From: Petricek, Robert J
Sent: Tuesday, September 20, 2005 4:09 PM
To: Lessard, Edward T; Glenn, Joseph W; Gmur, Nicholas; Kane, Steven F; Mortazavi, Payman; Sidi-Yekhlef, Ahmed; Wu, Kuo-Chen; Ganetis, George; Rakowsky, George; Tanabe, Toshiya; Harder, David A; Lehecka, Michael; Wanderer, Peter; Durnan, James T; Skaritka, John; Chouhan, Shailendra; Ribaud, Paul
Cc: Travis, Richard J; Alforque, Rodolfo; Kroon, Peter J; Rehak, Margareta L
Subject: Minutes of SCU Magnet Vertical Test Apparatus Walk Through

As a follow-up to LESHHC 05-02 (Minutes attached), a meeting was held on Friday September 9th in the Annex of Building 902 to inspect the SCU Magnet Vertical Test Apparatus as it is being assembled and prepared for phase I testing.

| Subject: | Prototype SCU VTF Phase 1 Test Procedure | | |

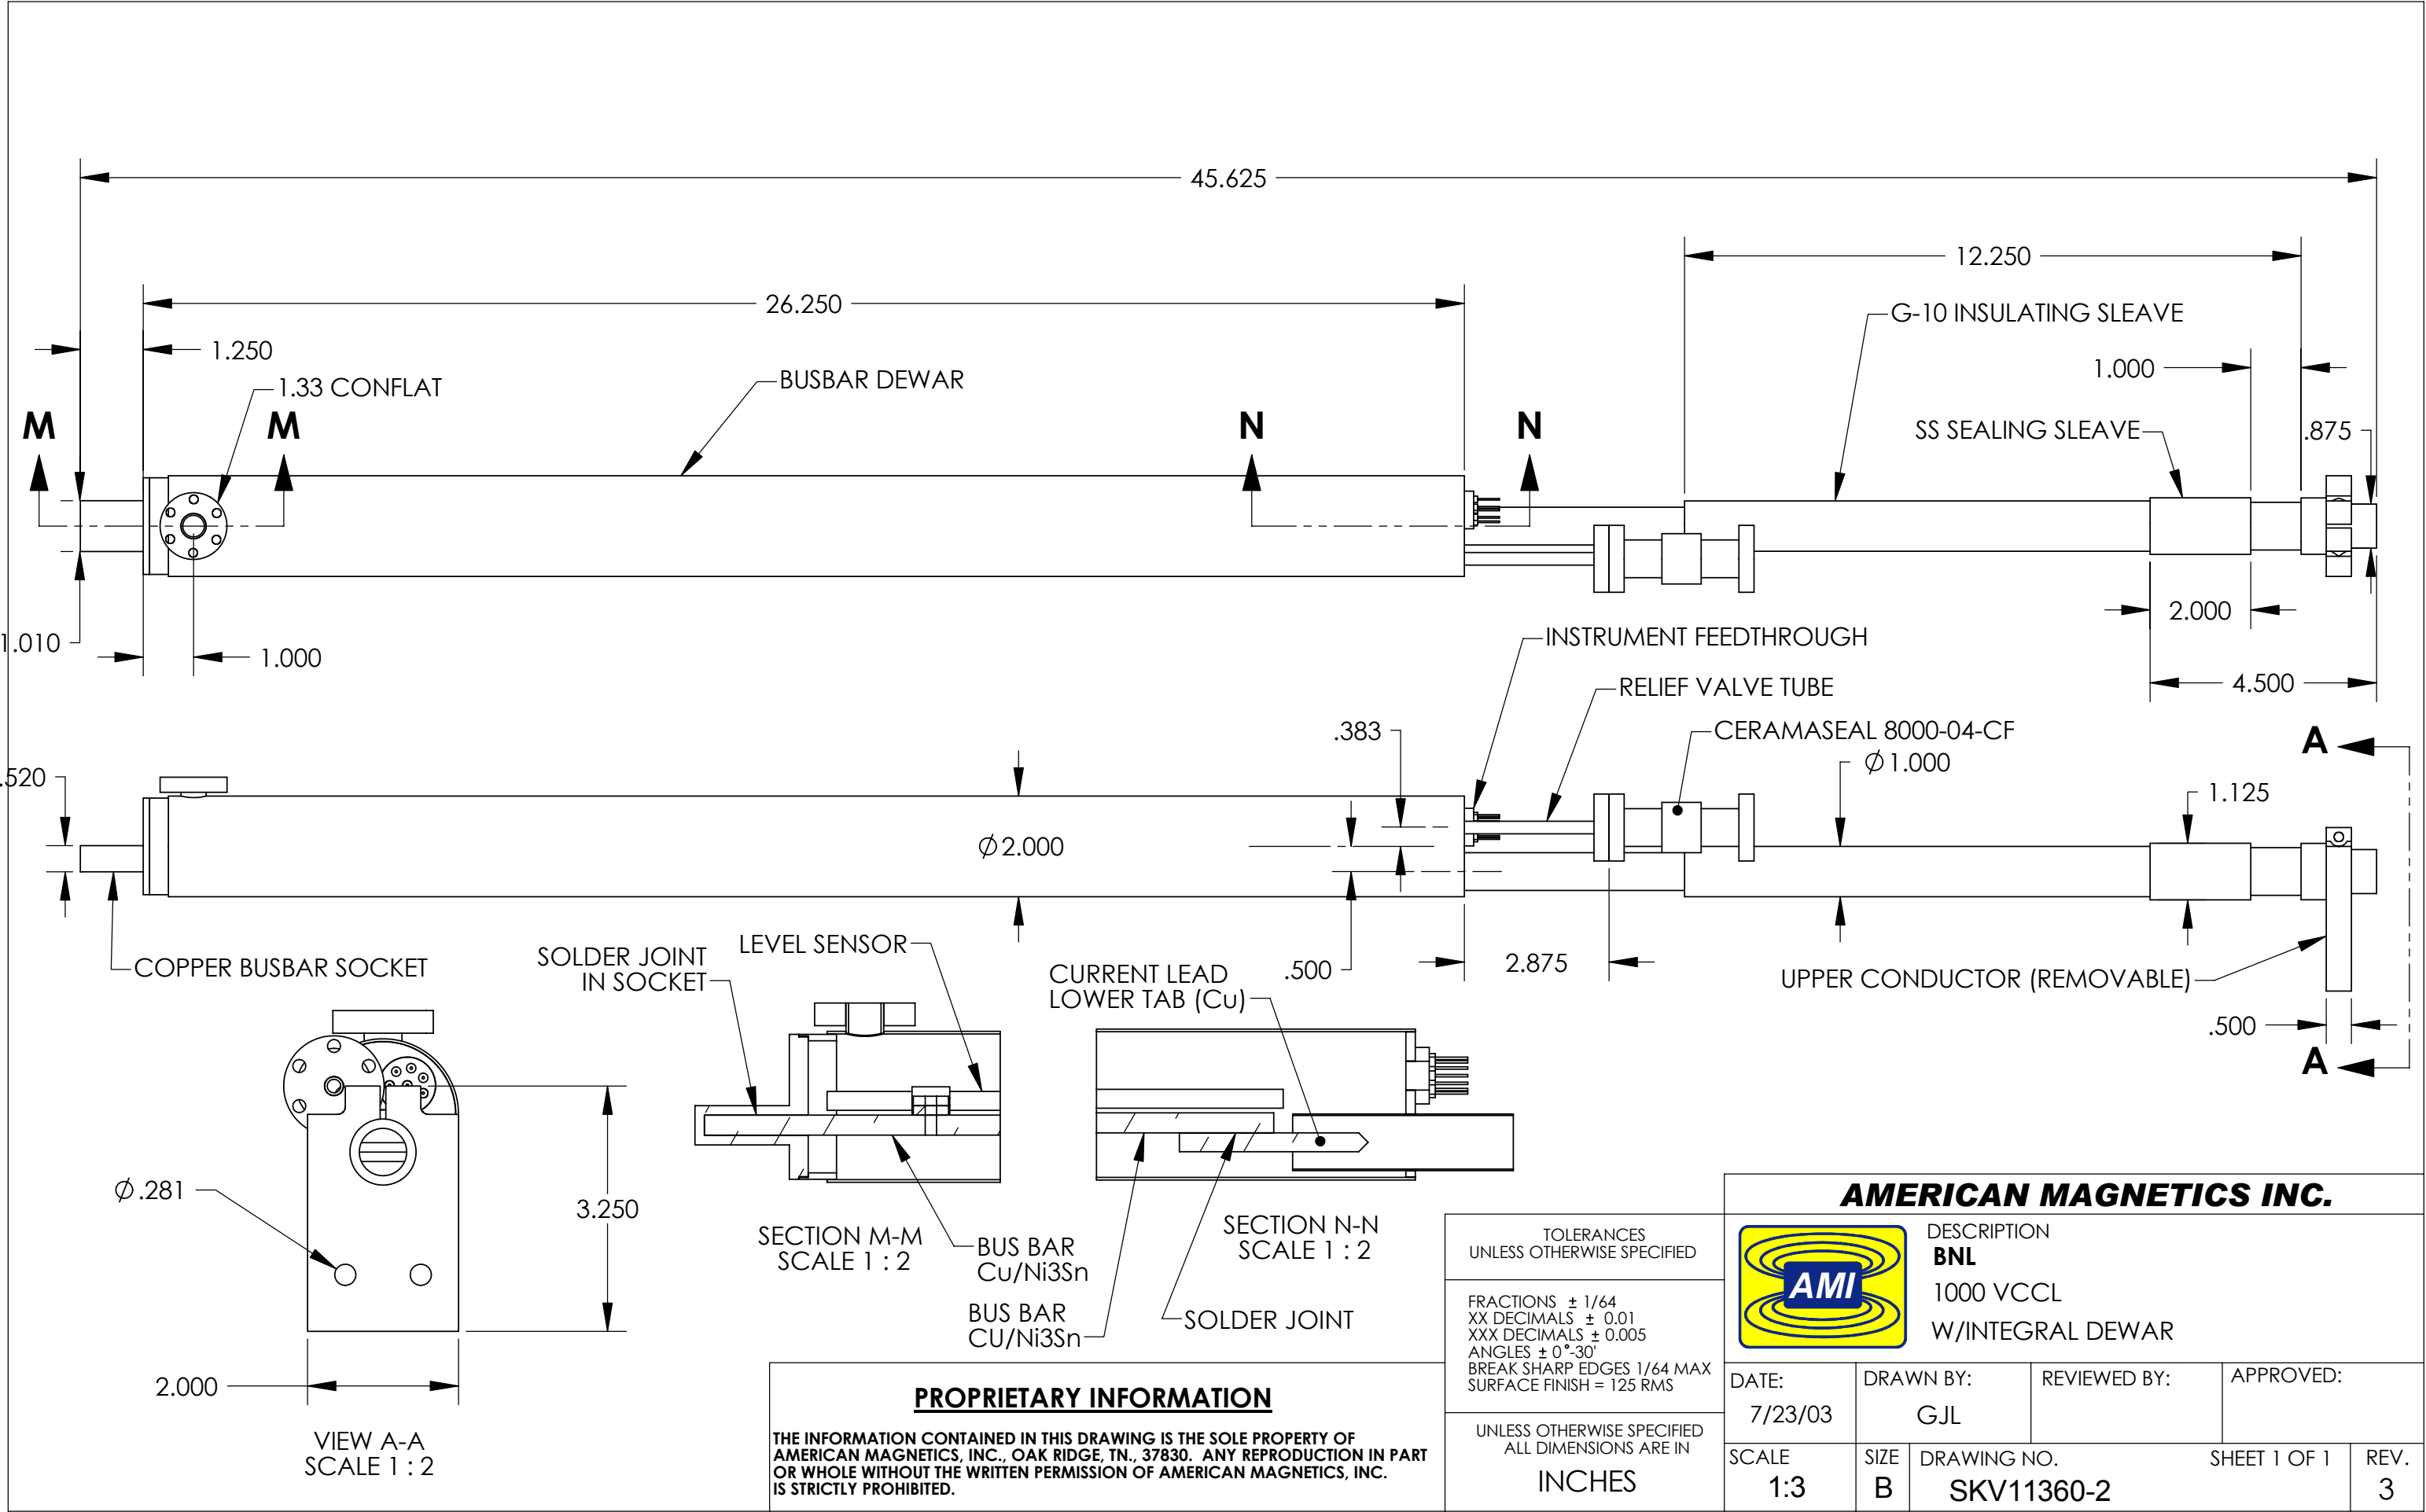
- Steve Kane questioned if the committee had reviewed the design of the lead cooling apparatus. Since the minutes of the committee meeting do not reflect this review a review should be completed.
ACTION: John Skaritka will submit to Steve Kane and to the committee design documentation of the lead cooling apparatus for distribution and review.

The first is a drawing from American Magnetics showing some of the requested information.

We have repeatedly requested additional information concerning the detailed Lead design but company will not give us any additional information.

They are stating the leads are 1000 amp capacity with about a 3 Lt /hour per pair boil off rate at full current. They designed properly so the gas exiting the lead will be near ambient temperature when run at the design current and further detailed information we are requesting is proprietary.

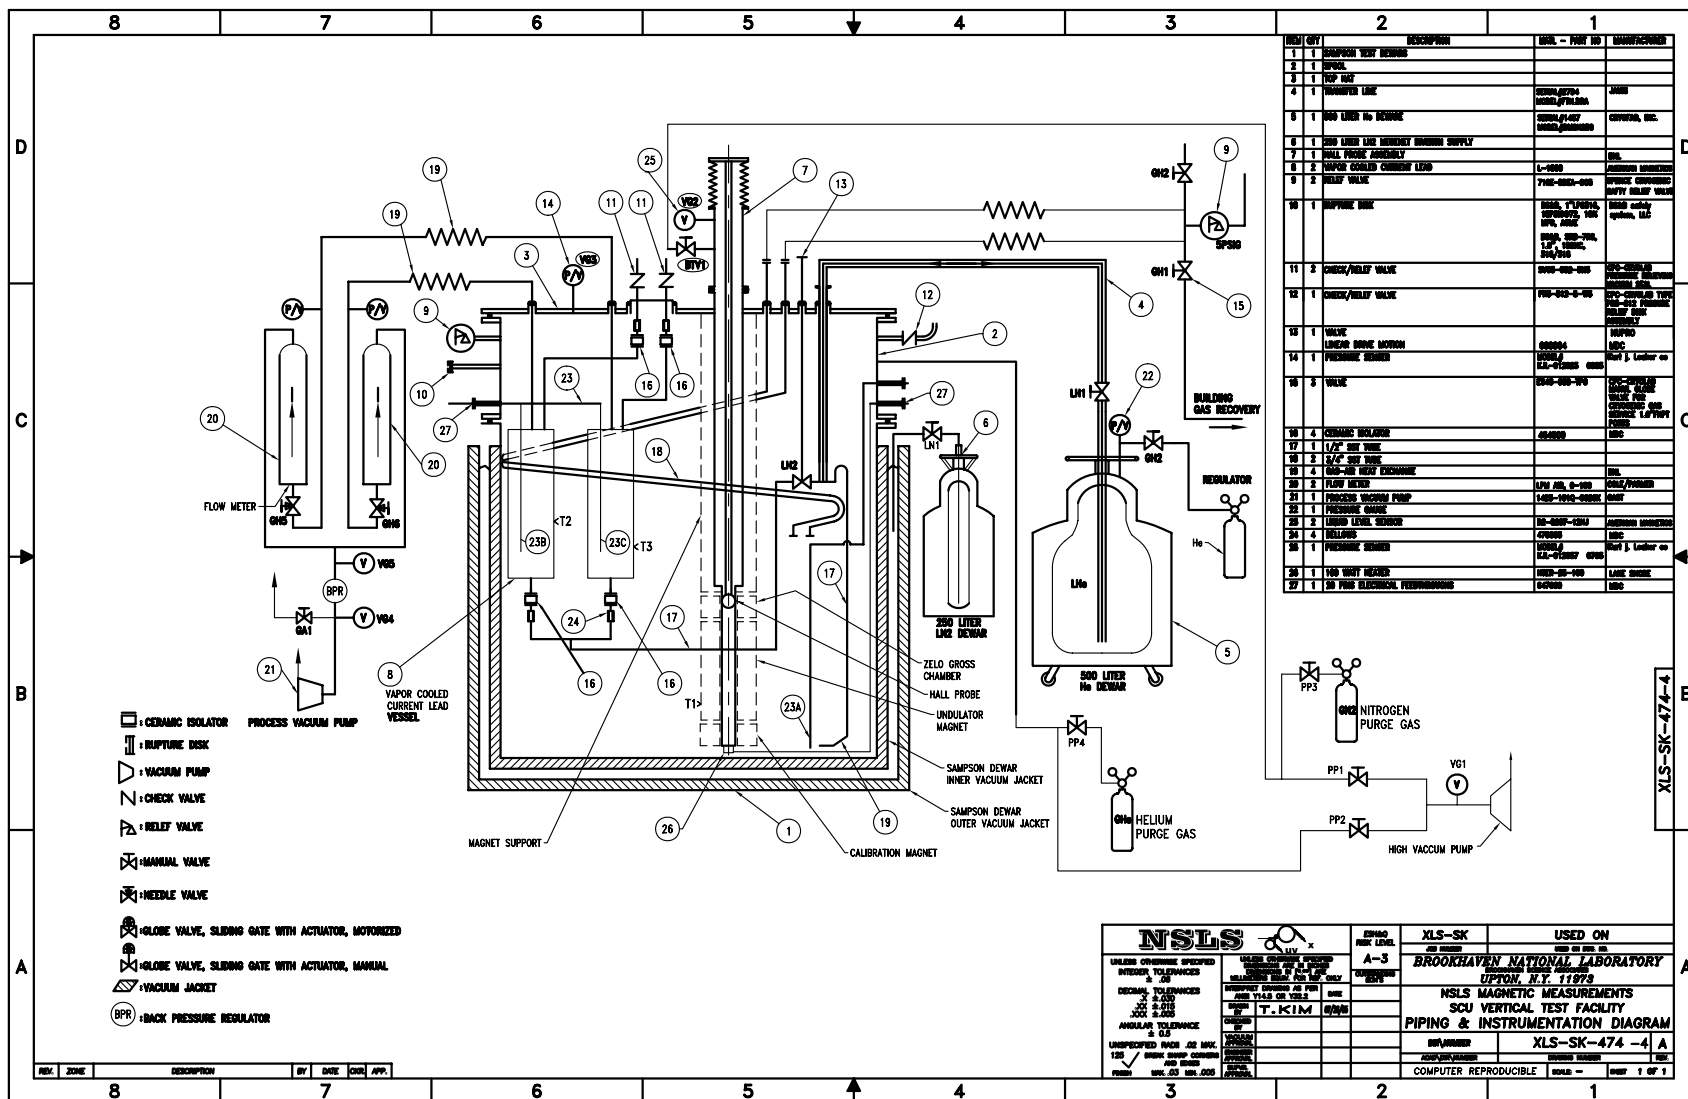
- Steve Kane asked if there was a fill procedure for the lead cooling apparatus. The test procedure only had a re-fill procedure.
ACTION: John Skaritka will submit to the Robert Petricek for distribution to the committee an updated copy of the test procedure including the fill procedure for the lead cooling apparatus.
Action: Steve Kane will review the operating procedure and P&ID and provide comments to John Skaritka.

The second attachment is the P&ID in a .pdf format.
